SLICE Updates for FLEX-GTR

December 2, 2009

Software Problems Reported with FLEX-GTR - Overview

Specific Problems Reported

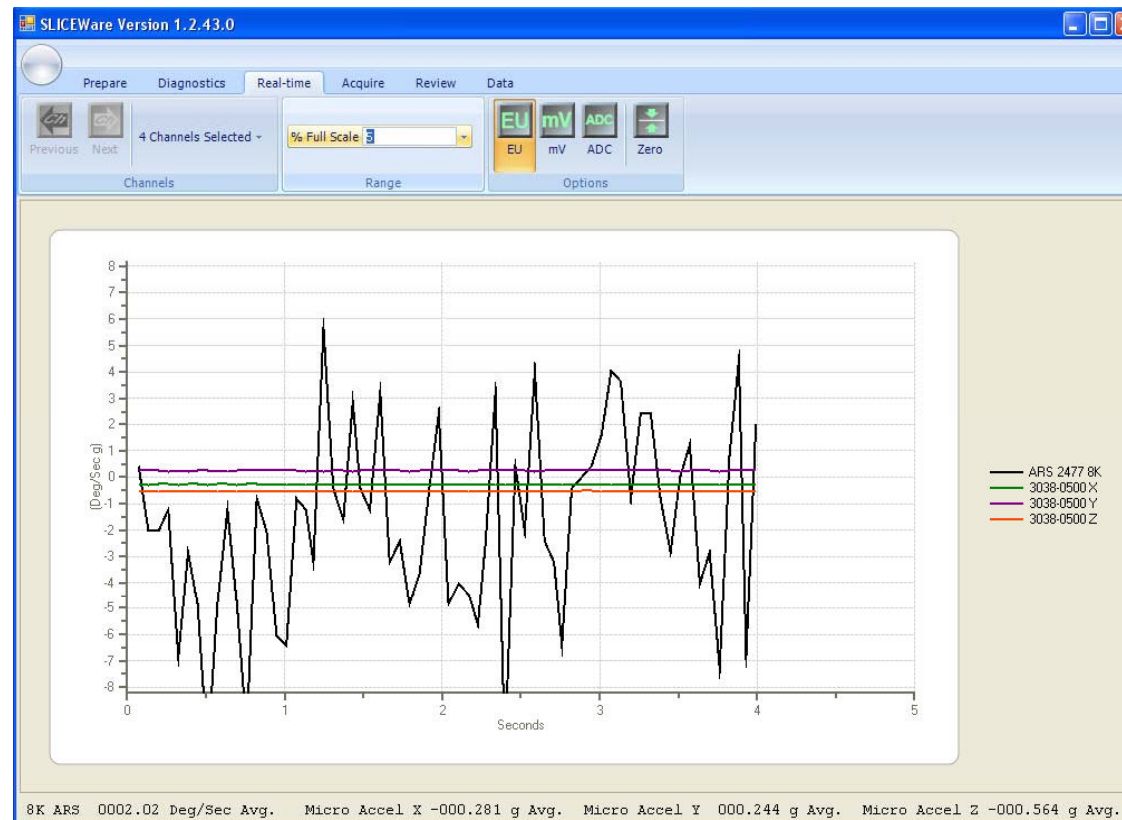
- Plotting multiple channels – This feature will be added in the first quarter of 2010

Specific Problems Reported

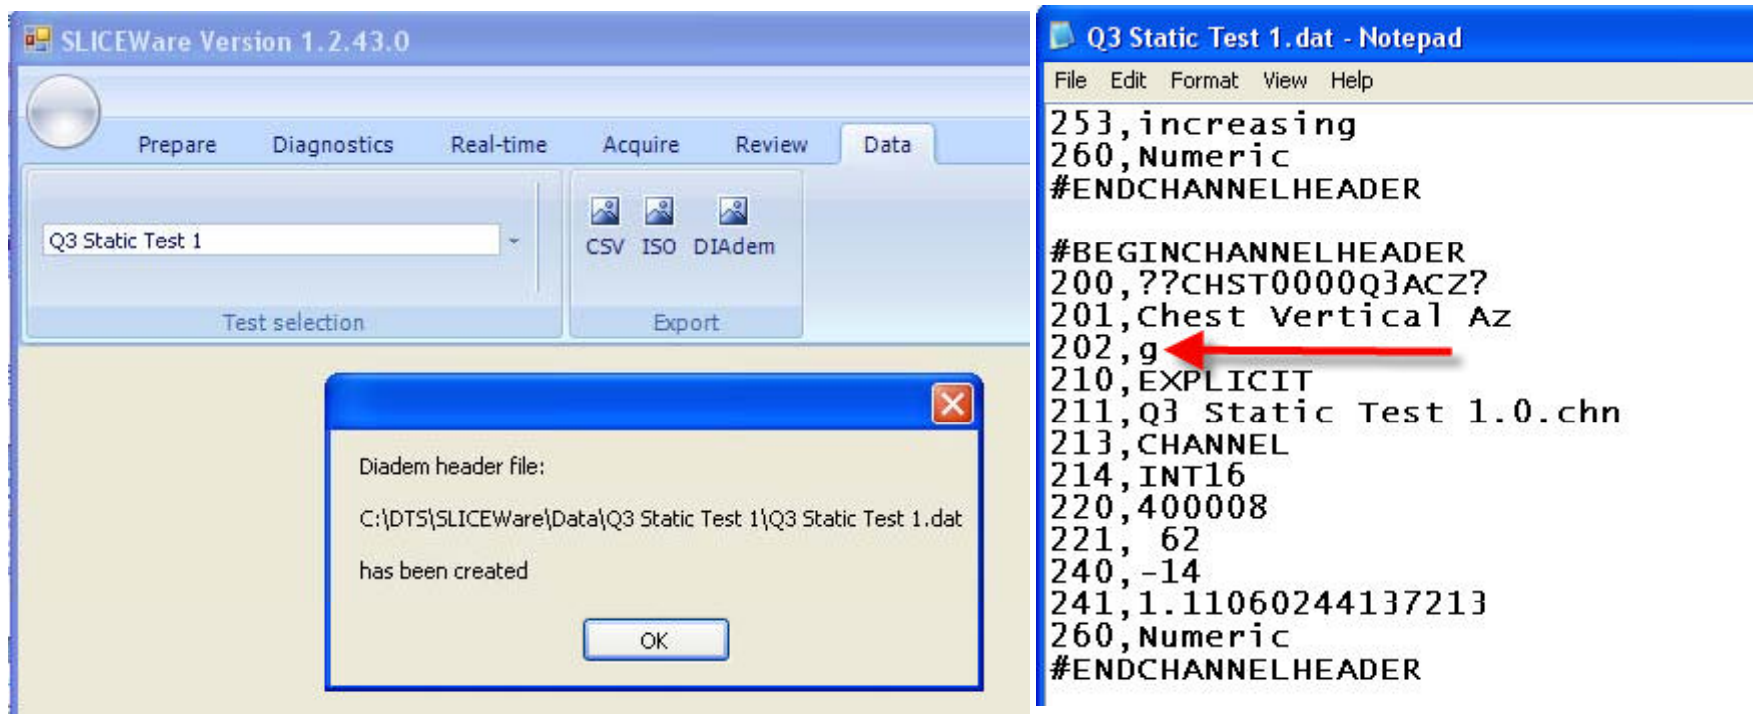
- DIADEM export – This has been corrected in SLICEWare 1.02.133

Specific Problems Reported

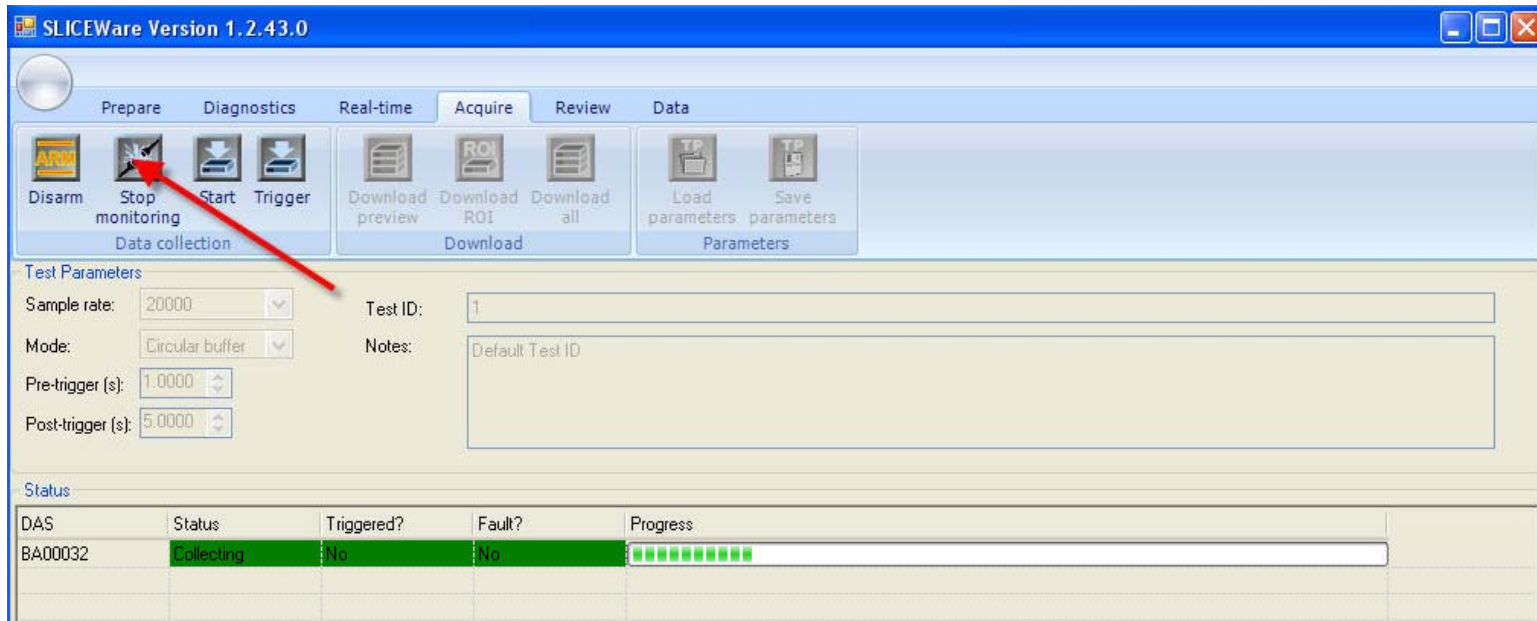
- Disconnect during status monitoring – this has been corrected in version 1.03.

Specific Problems Reported

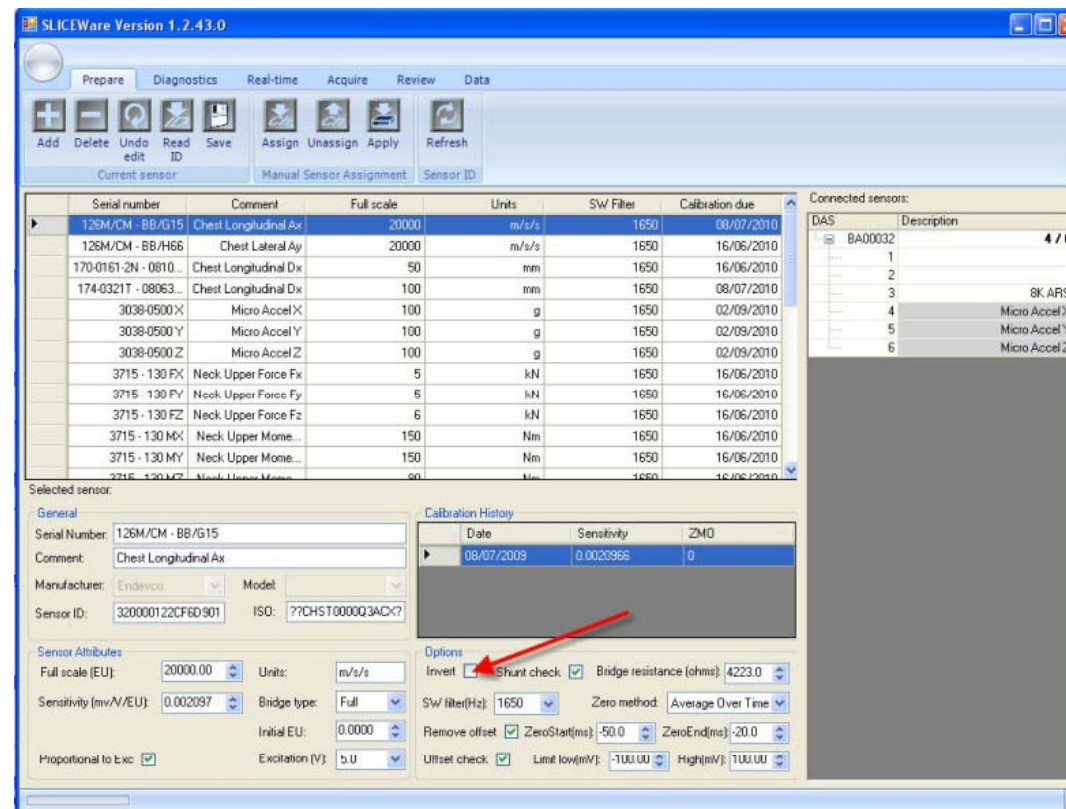
- Polarity – All versions of SLICEWare offer an easy feature for inverting polarity in software.

FLEX-GTR Hardware Issues

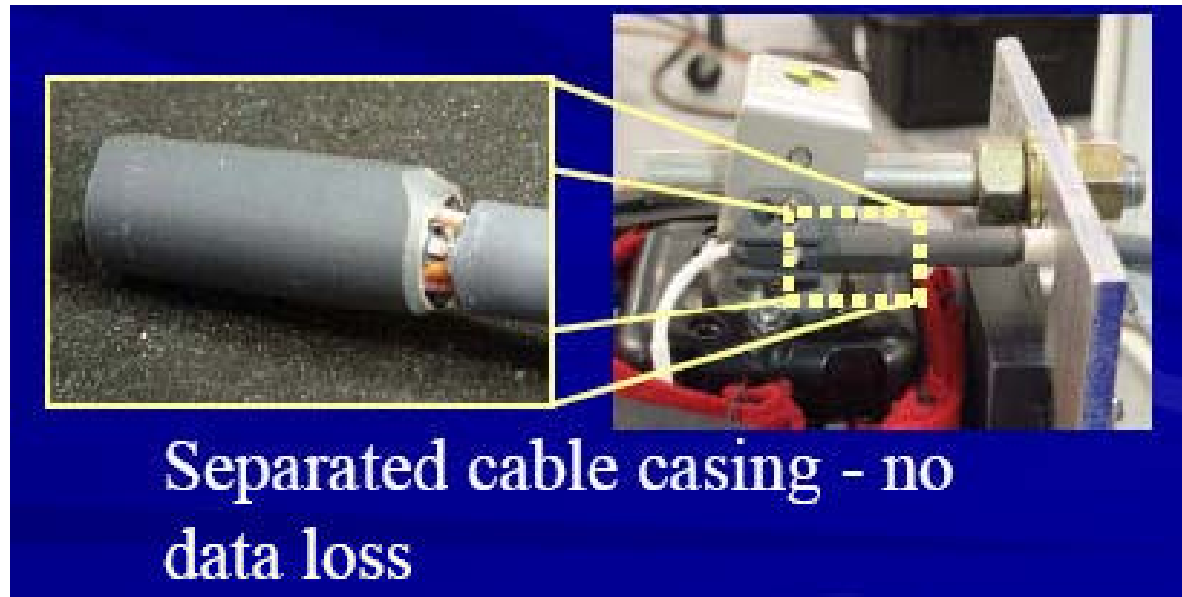
- Cable separated from back shell – Design has been improved to provide increased strain relief and strength

FLEX-GTR Hardware Issues

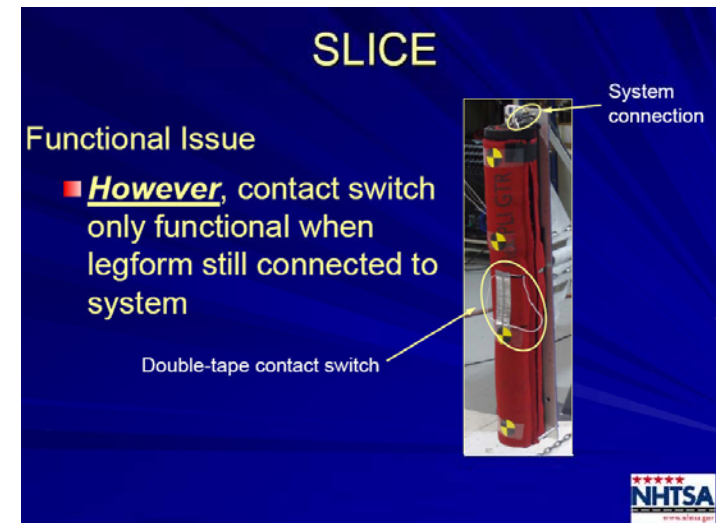
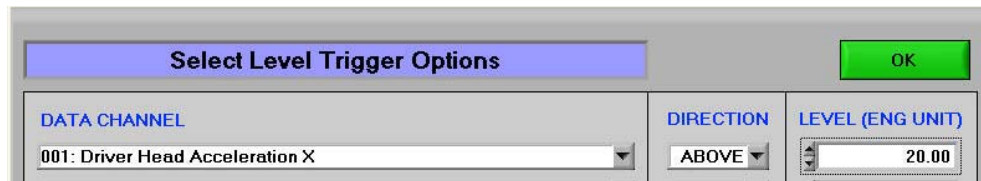
- Contact switch – when used with Recorder Mode it is possible to synchronize off board SLICE with FLEX-GTR SLICE
 - Both on board and off board SLICE receive Start Record signal
 - On board SLICE records event through contact switch
 - Using latest software, during download both systems are synchronised based on Start Record signal.
 - Level Trigger Option – first quarter of 2010
